DATE: February 5, 2026

ADDENDUM NO. 5

PROJECT NO. DGS C-0946-0012 PHASE 006
PROJECT TITLE - PA State Museum & PHMC Tower - Infrastructure Upgrades and Renovations
PROFESSIONAL:
Design Resources Group Architects AIA
270 Davidson Ave, Suite 303
Somerset, NJ, 08873

DRAWN BY	DATE	DRAWING NUMBER
M. TILIAKOS/J. JOLIN	10.10.2025	**A105.3**
CHECKED BY	SCALE	
J. HOEPPID/ VODZAK	AS NOTED

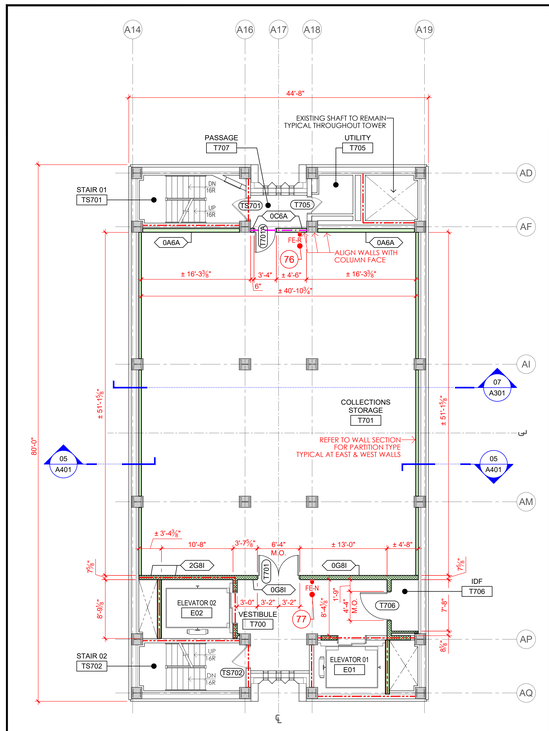
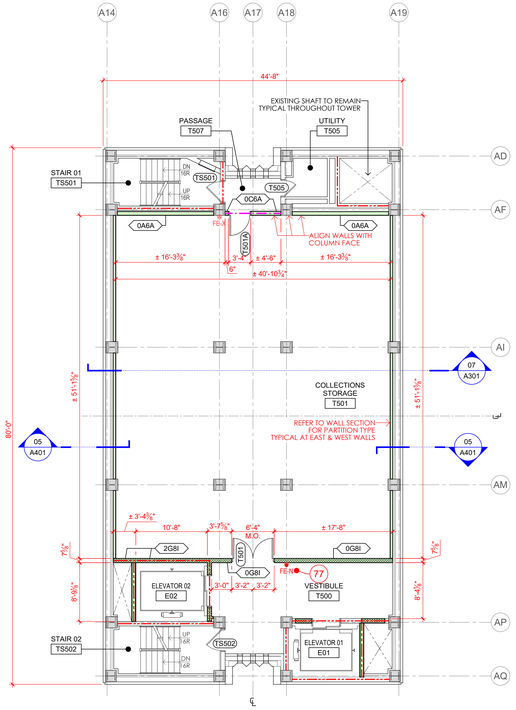
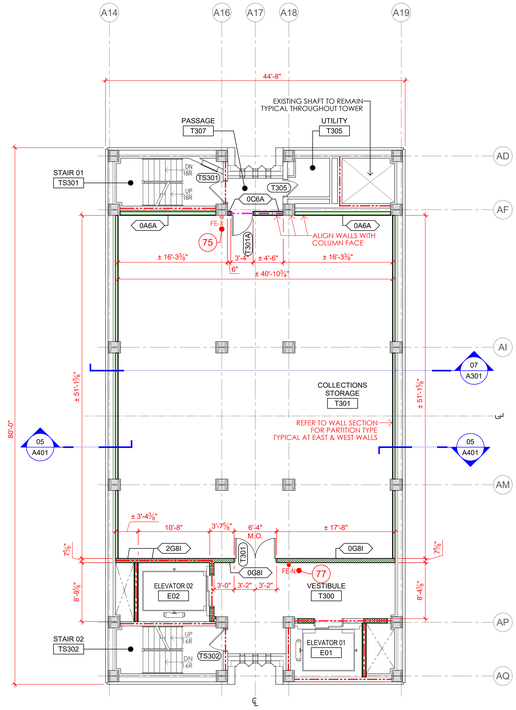
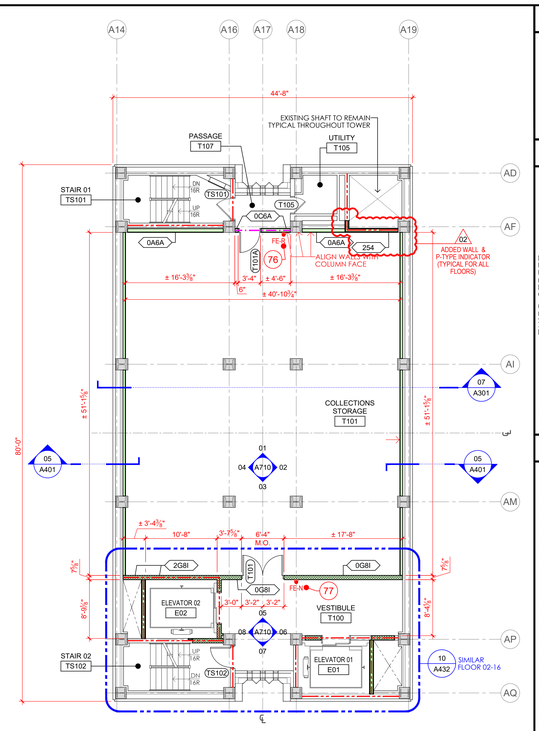
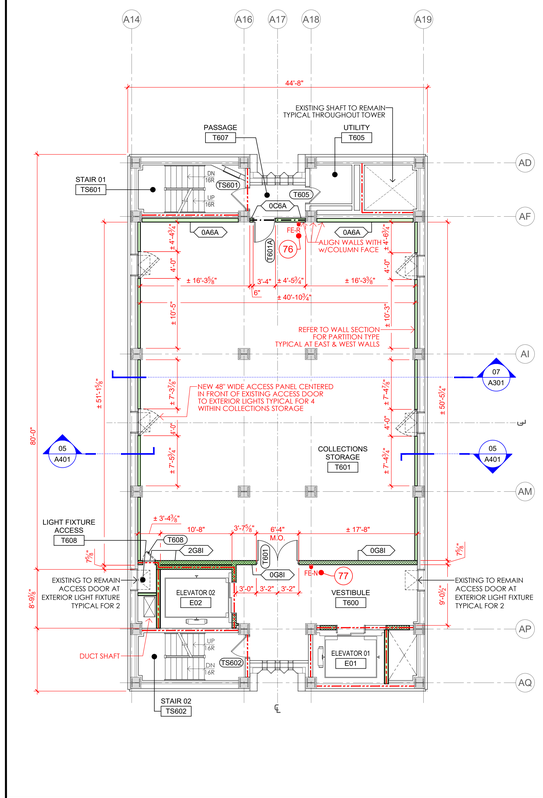
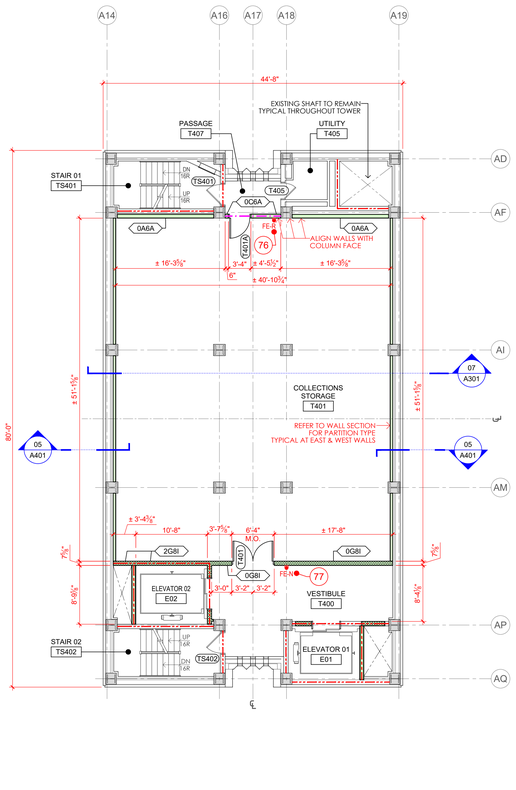
Item 6 - Drawing A105.3 - Added detail indicator for all columns requiring column wraps under Base Bid 3.

Item 7 - Drawing A105.3 -For OGP-2 (operable partition at the north side of Large Conference 542), revised the track from curved/segmented to a straight line.

FILE PATH: X:\Projects\Harrisburg\4949_0946\04\4949_0946_A113_Tower Floors 16 Roof_R25\D.rvg
PLOTTED BY: CLOSE
PLOTTED: 26.02.03 09:32 AM
LAST SAVED: 26.02.03 09:32 PM

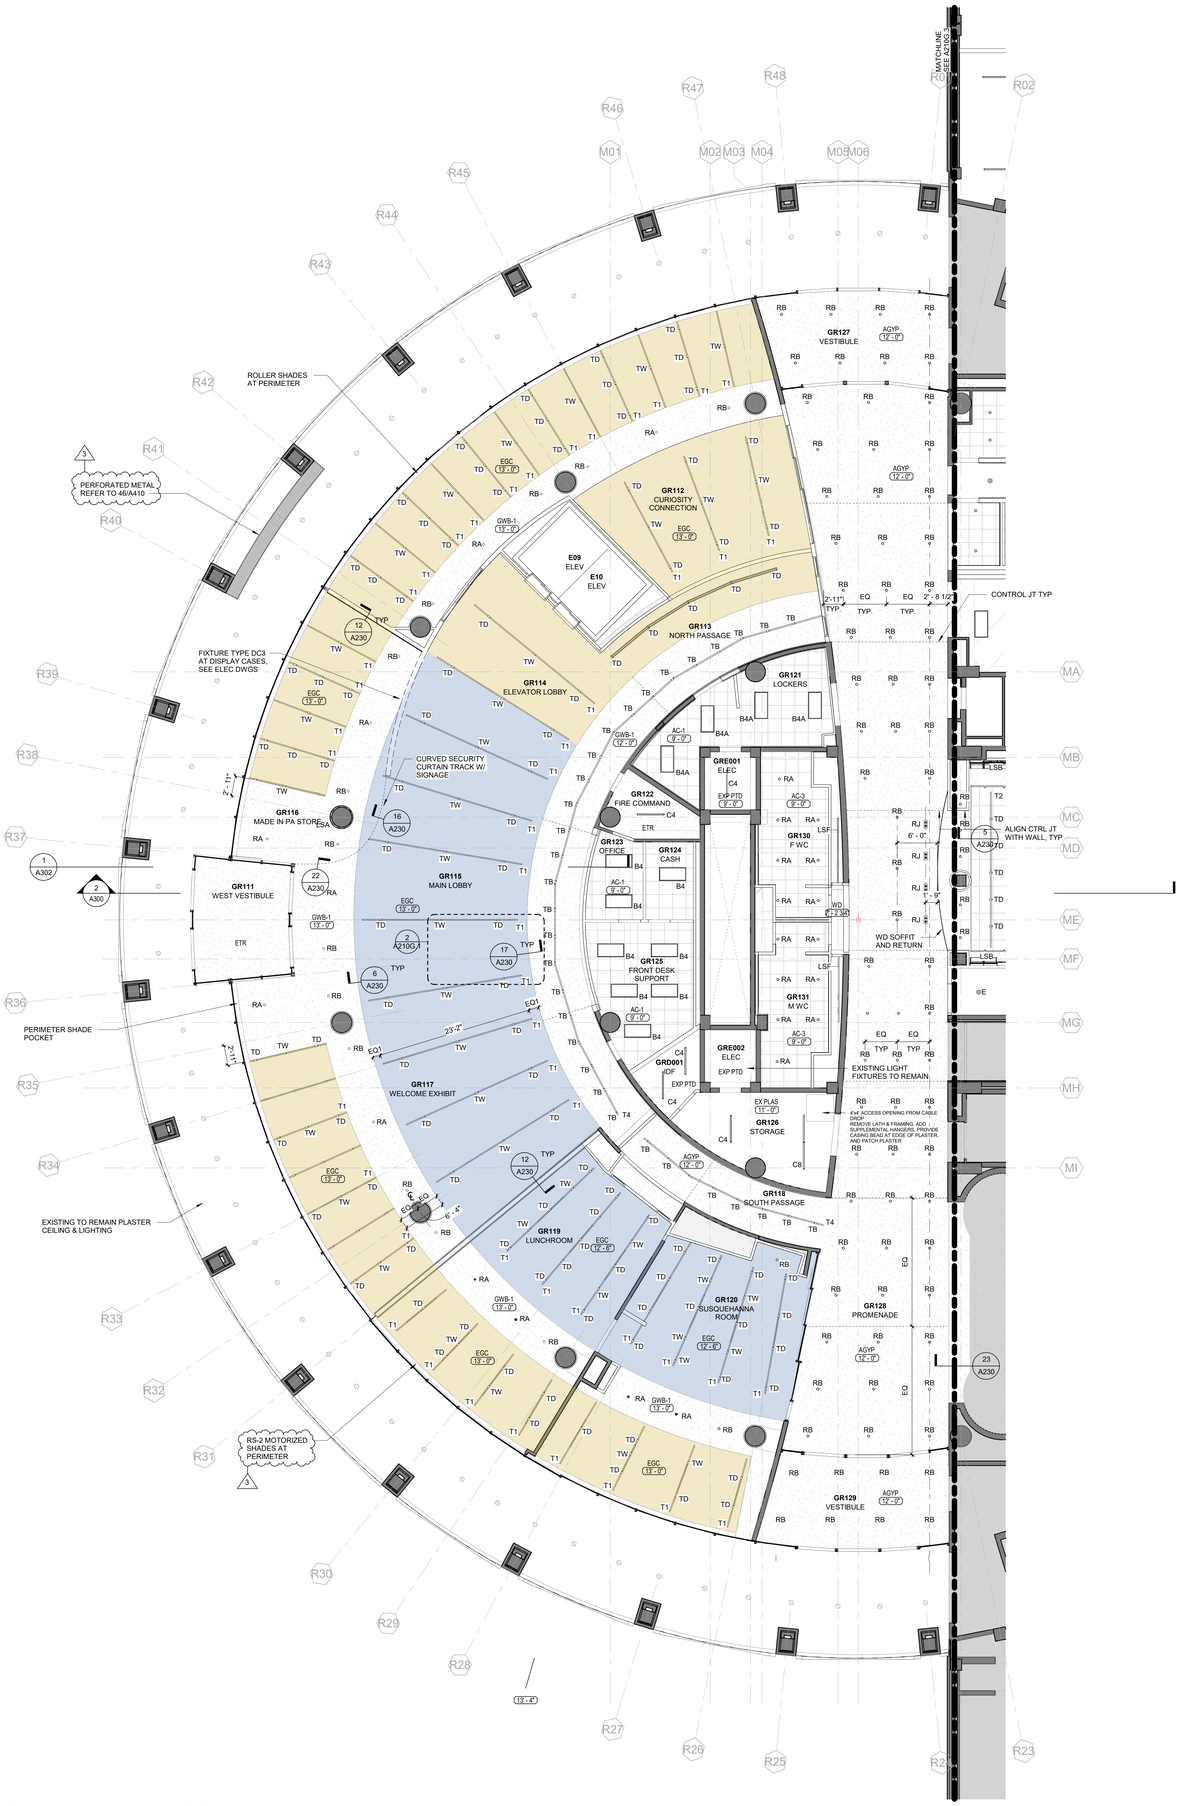
Item 9 - Drawing A113 - Added note to the 18th floor plan indicating that the new steel framing for the 19th floor west above requires 2-hour fireproofing.

PHMC TOWER - 6TH FLOOR - SECTION **25**

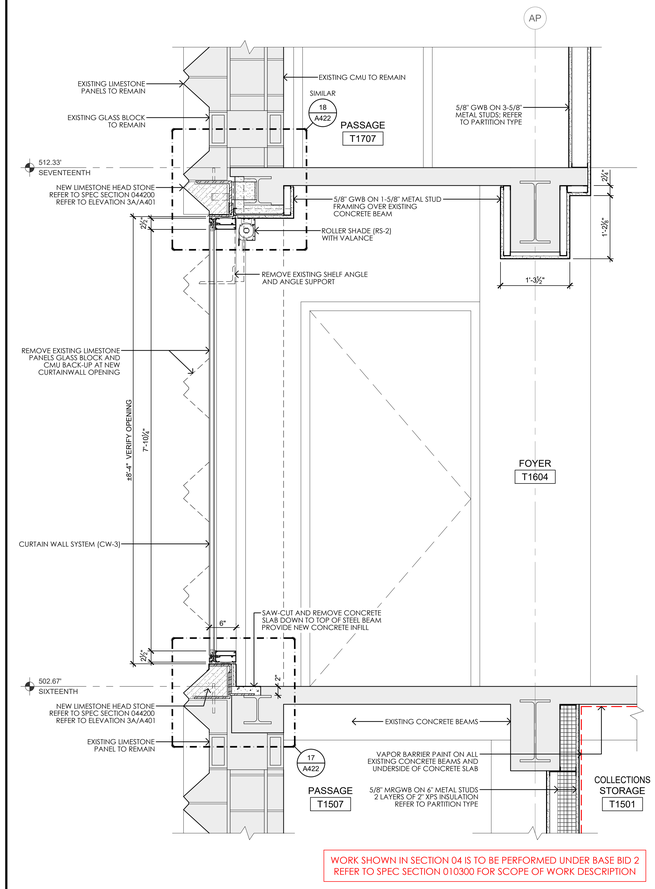
Item 14 - Drawing A406 - At Detail 25, adjusted location of 6th floor beam. Added note to provide fireproofing for 7th floor beam and replaced 7th floor beam above door with bond beam to be consistent with structural drawings.

PHMC TOWER ELEVATOR E02 - FRONT TO BACK 8B

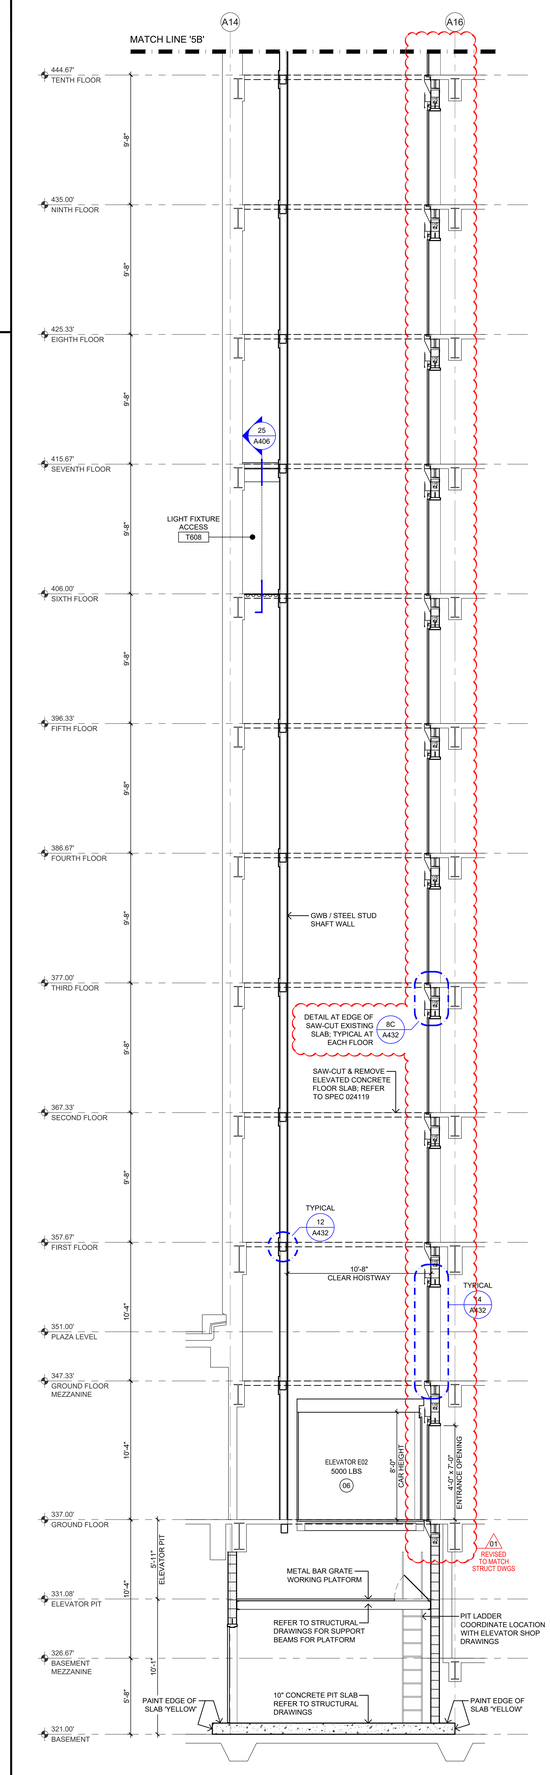
Item 20 - Drawing A432 - At Section 8A, showed steel beams supporting floor slab that are within the CMU wall to be consistent with structural drawings.

PLOTTED BY: CLOSE
PLOTTED: 26 Oct 08:47 AM
FILE PATH: X:\Projects\Harrisburg\4949.00\RCH\A821_Millwork Front Desk GR110.dwg
LAST SAVED: 25 Oct 11:57 AM

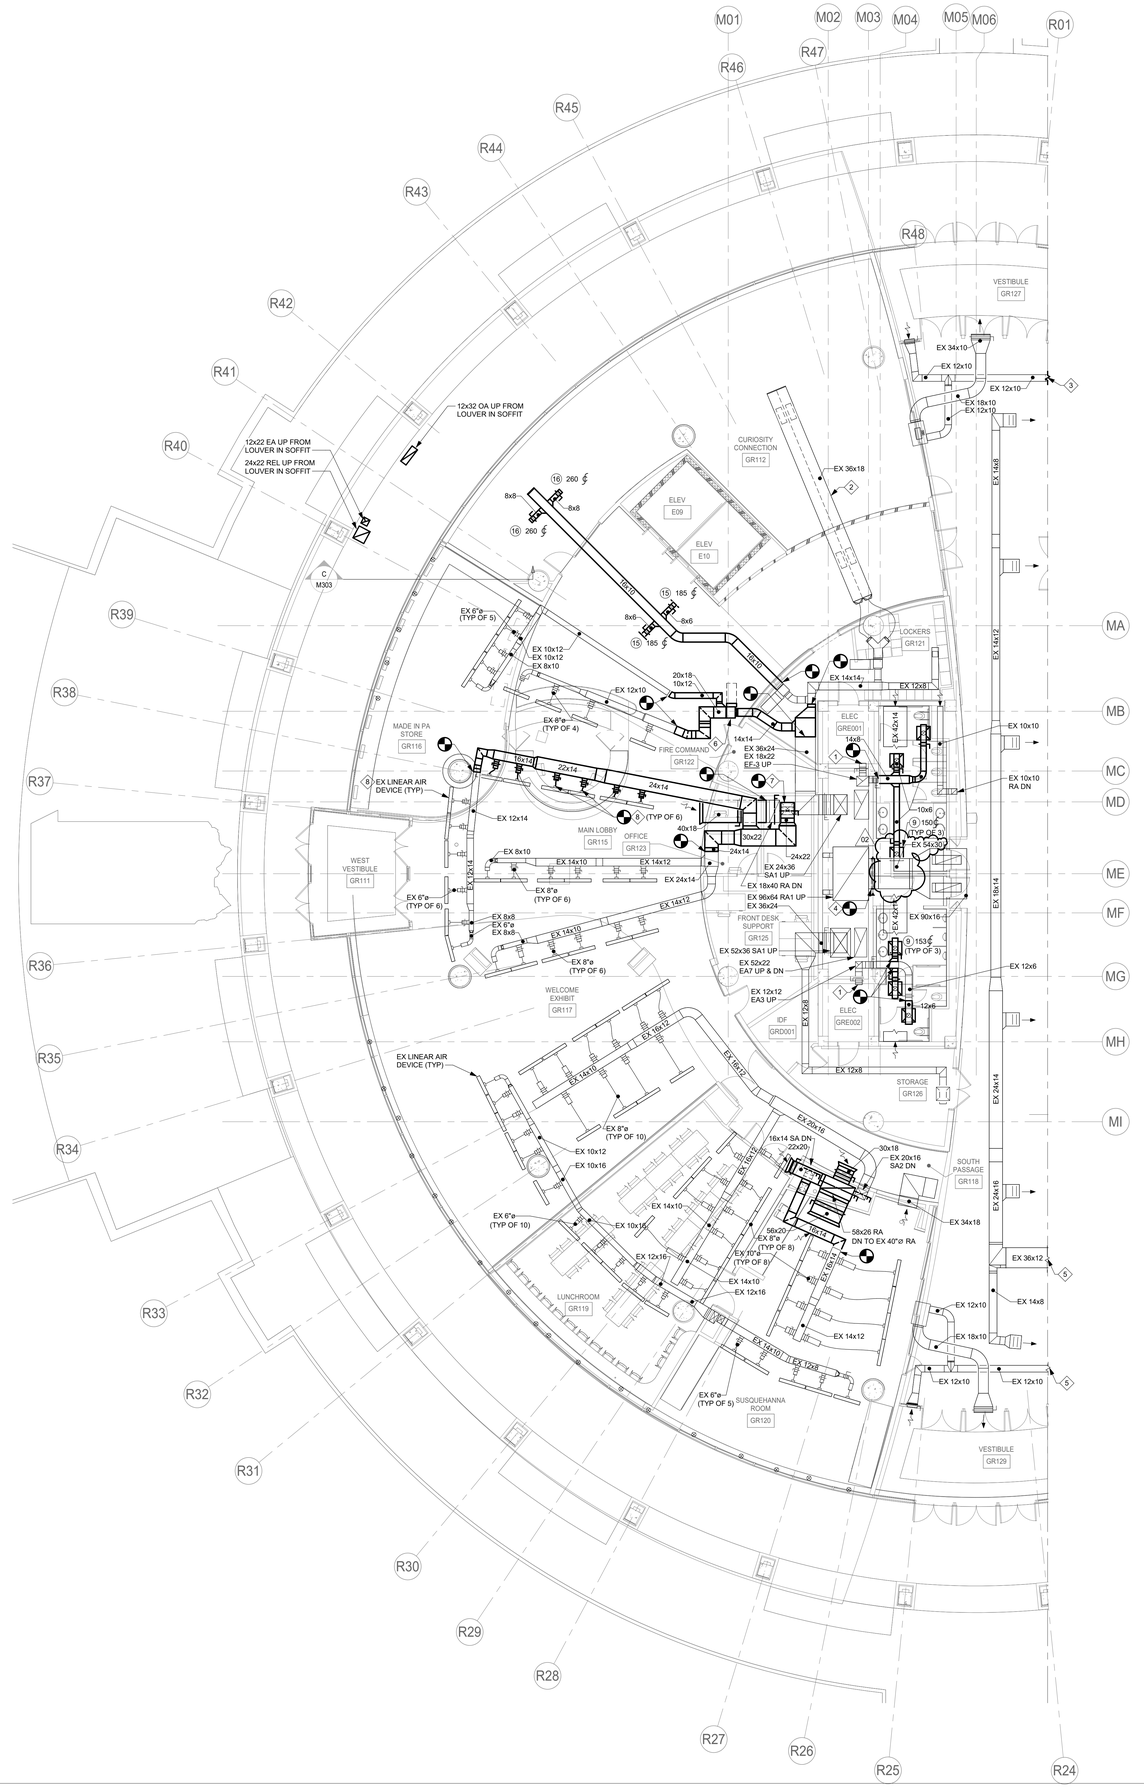
Item 5 - Refer to 15, 16 and 17/A821 for details covering millwork in Large Conference Room 542, which is included under Base Bid 3.

Item 25 - Drawing A821 - Added note for Details 15, 16 and 17 to indicate millwork at Large Conference Room 542 is under Base Bid 3.

DRAWN BY	DATE	DRAWING NUMBER
KEH	10/10/2025	M100G.1
CHECKED BY	SCALE	
DC	1/8" = 1'-0"

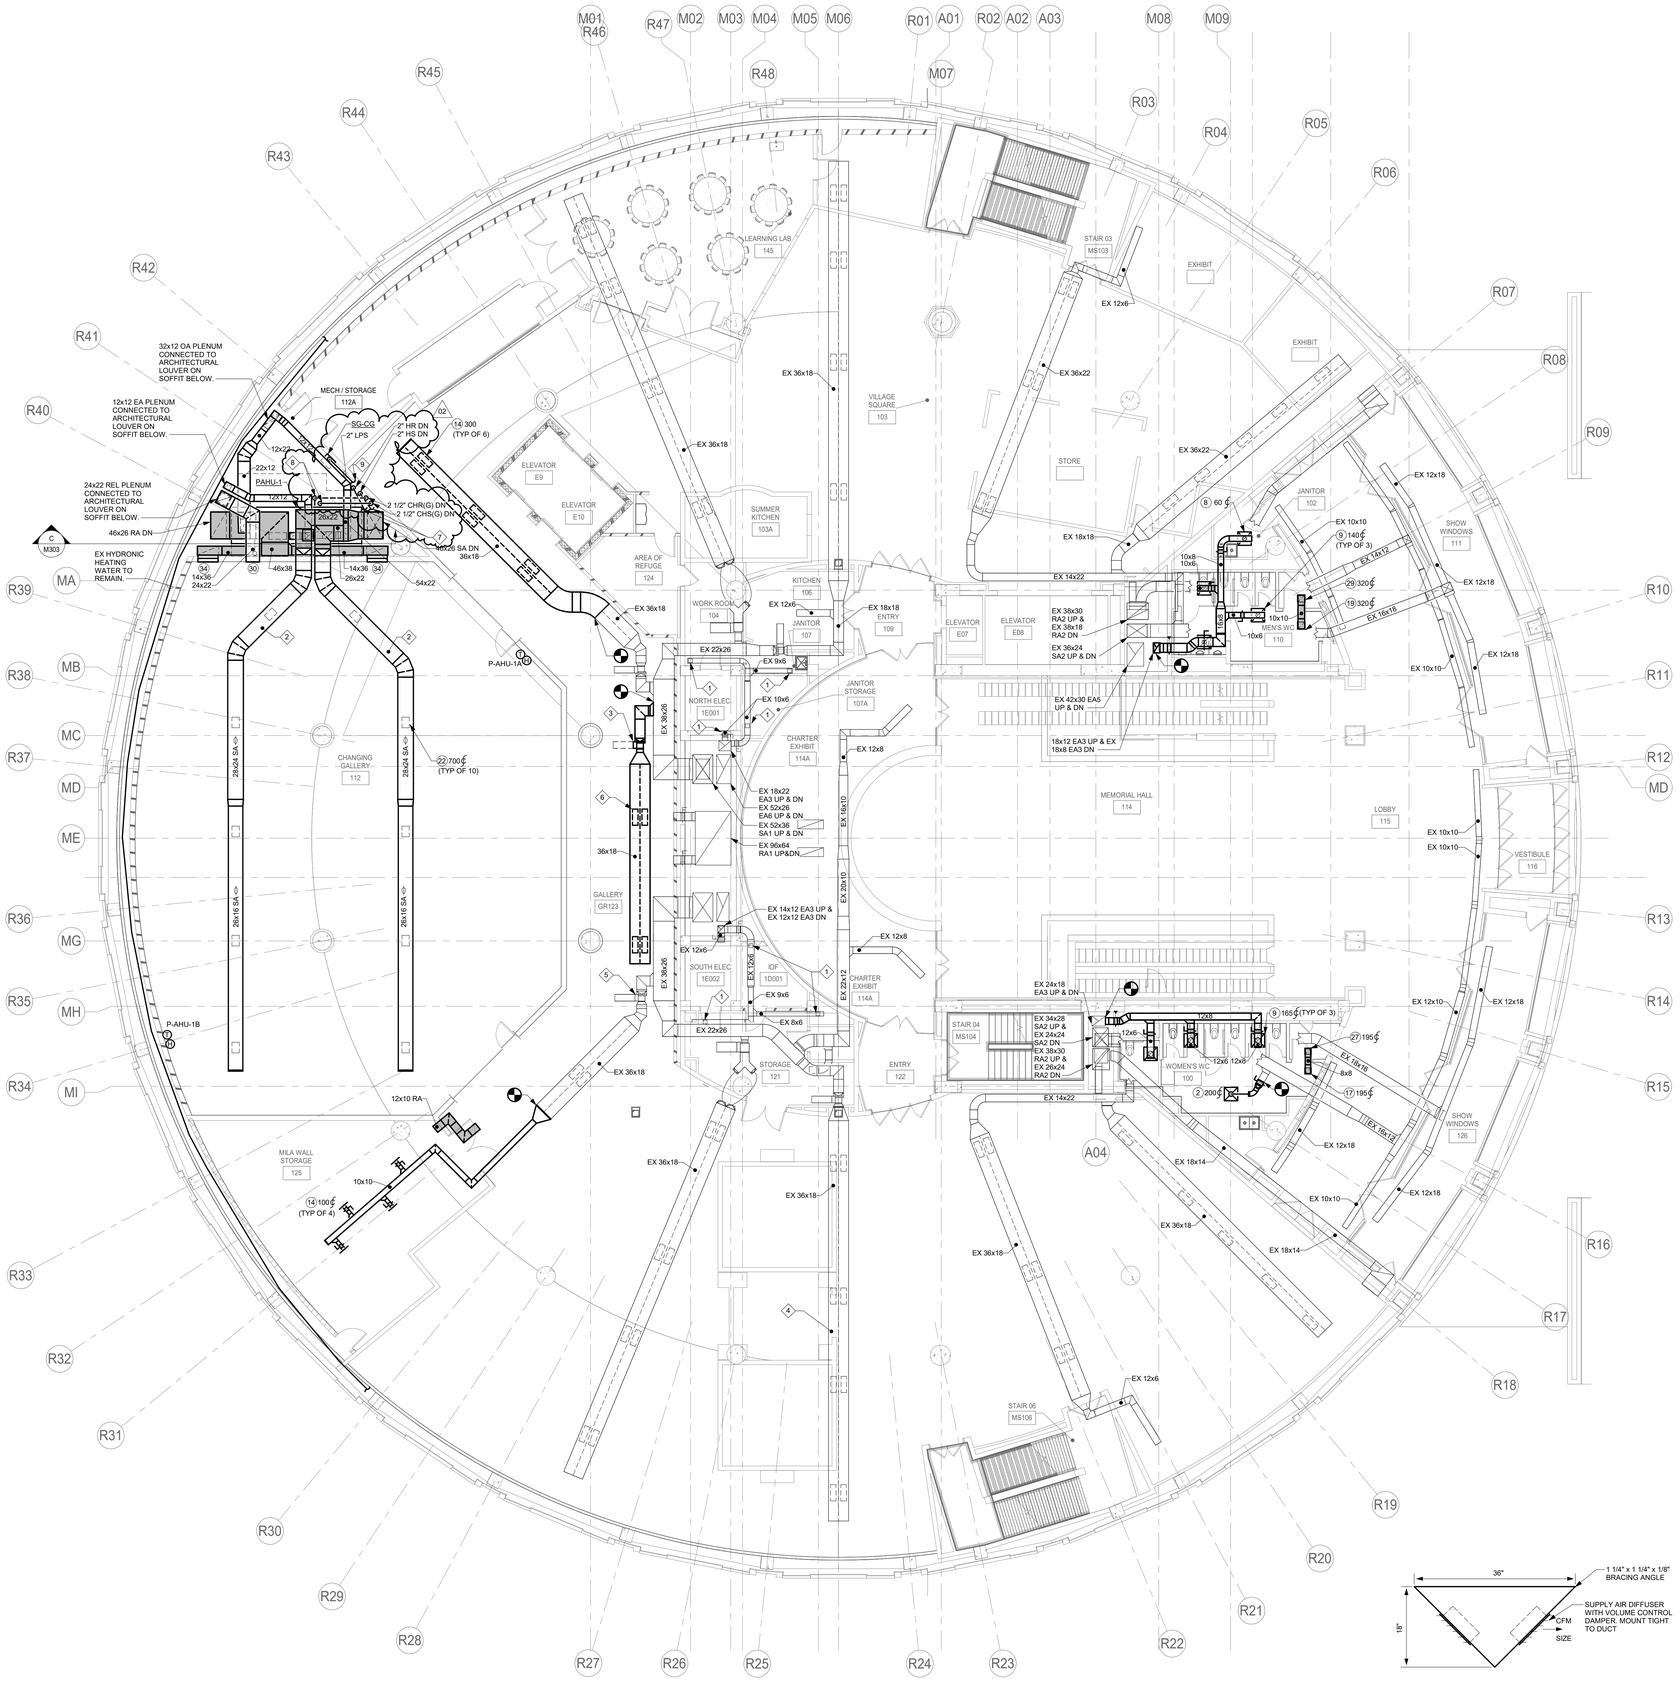
Item 31 - Drawing M100G.1 - Near Column Line ME, added size for fire/smoke damper at existing duct, 54x30.
